ARCATA WOODS SUBDIVISION

Revised for the September 21st meeting:

APPLICATION NUMBER Holdover DATE September 21, 2006
APPLICANT Arcata Woods Subdivision
REQUEST Subdivision

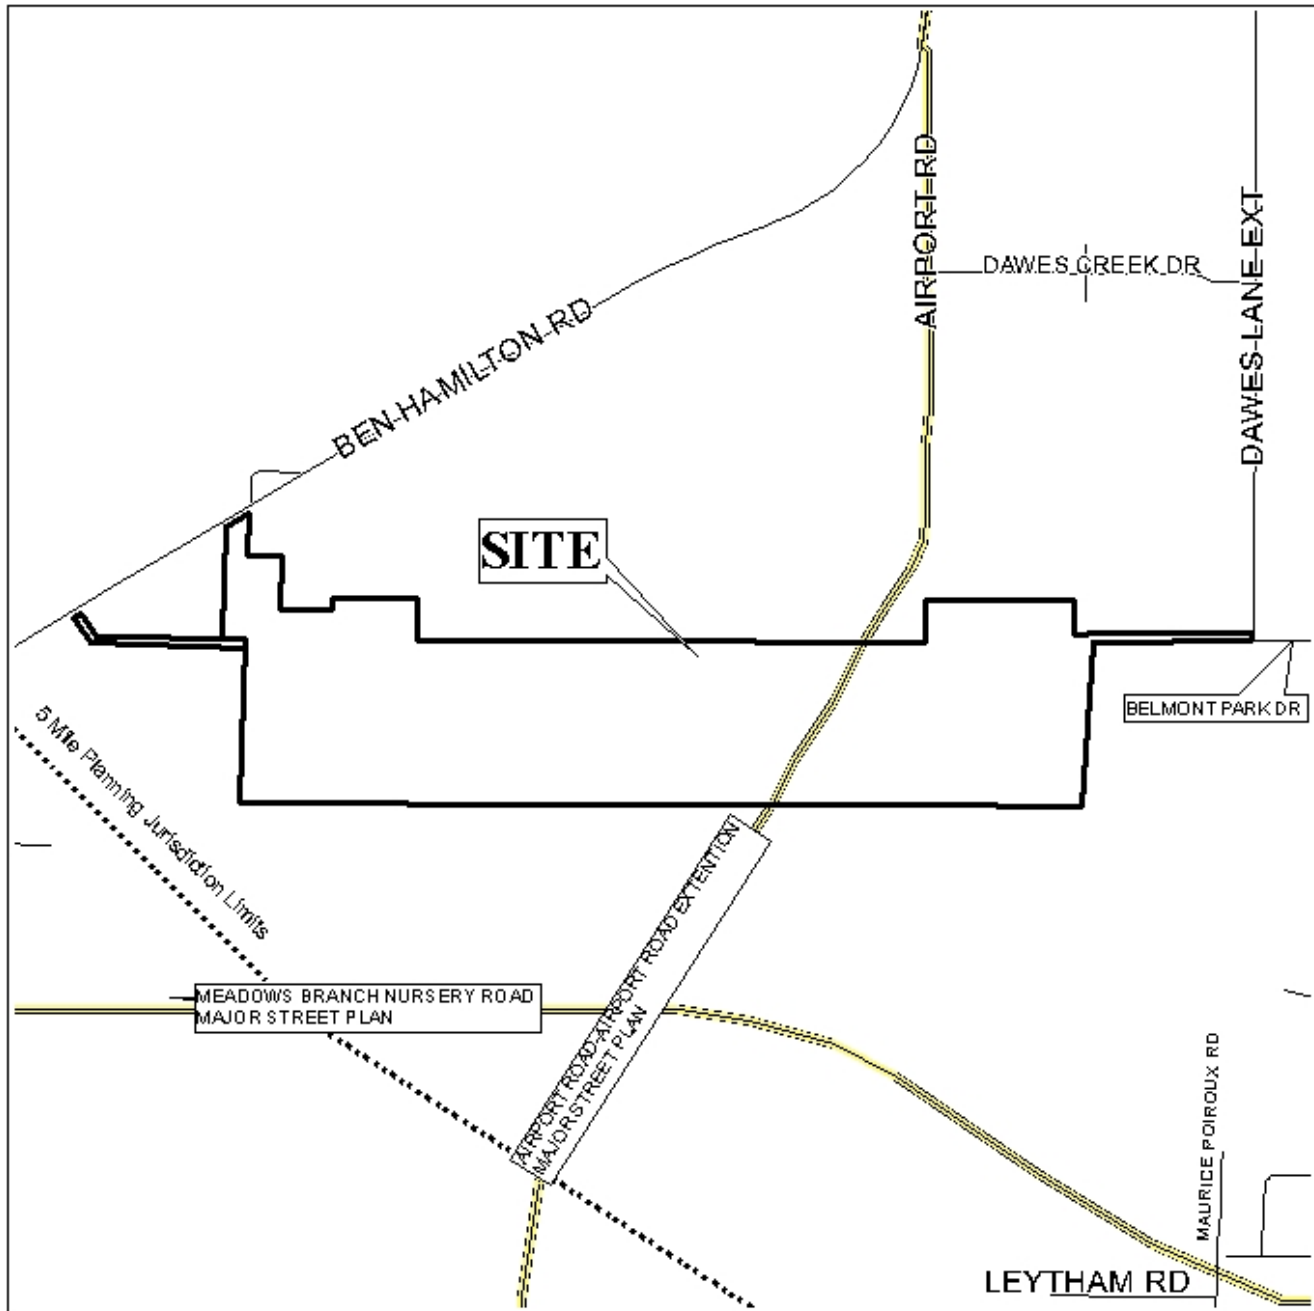
The applicant has submitted a revised plat depicting 419 lots. The revised plat has addressed most of the previously expressed concerns.

Connectivity to adjacent land-locked parcels is still a concern. In addition to the existing street stubs, it is recommended that one street stub be provided to the land-locked parcel North of proposed lots 20-21 and 26-27 in Phase Four, and that one street stub be provided to the land-locked parcel South of Phase Six.

Finally, there are still small pieces of land that are not included with proposed lots, or labeled as greenspace. Land near proposed lots 7, 187-190, and 390 should either be incorporated into the adjacent lots, or identified as greenspace common areas.

Based upon the preceding, the revised 419 lot plat is recommended for Tentative Approval, subject to the following conditions: 1) provision of street-stubs to the land-locked parcel North of proposed lots 20-21 and 26-27 in Phase Four, and the land-locked parcel South of Phase Six, in compliance with Section V.B.1. of the Subdivision Regulations; 2) identification of all portions of the site to fully account for all acreage and the manner of site development, specifically the land near proposed lots 7, 187-190, and 390; 3) depiction of any existing drainage easements associated with previous subdivisions (Lot 1, Duncan Subdivision); 4) identification of the size of all lots in square feet, either via a table on the plat, or by the labeling of each lot, to ensure that each lot meets the minimum lot size identified in Section V.D.2. of the Subdivision Regulations; 5) depiction of the 25-foot minimum building setback line, in conformance with Section V.D.9. of the Subdivision Regulations; 6) identification and labeling of all common areas, including greenspaces, road medians, and detention areas, and placement of a note on the plat stating that maintenance of all common areas shall be the responsibility of the subdivision's property owners; 7) placement of a note on the plat stating that access to the 60-foot roadway easement on the West side of site is denied; and 8) placement of a note on the final plat stating that any lots which are developed commercially and adjoin residentially developed property must provide a buffer, in compliance with Section V.A.7. of the Subdivision Regulations.
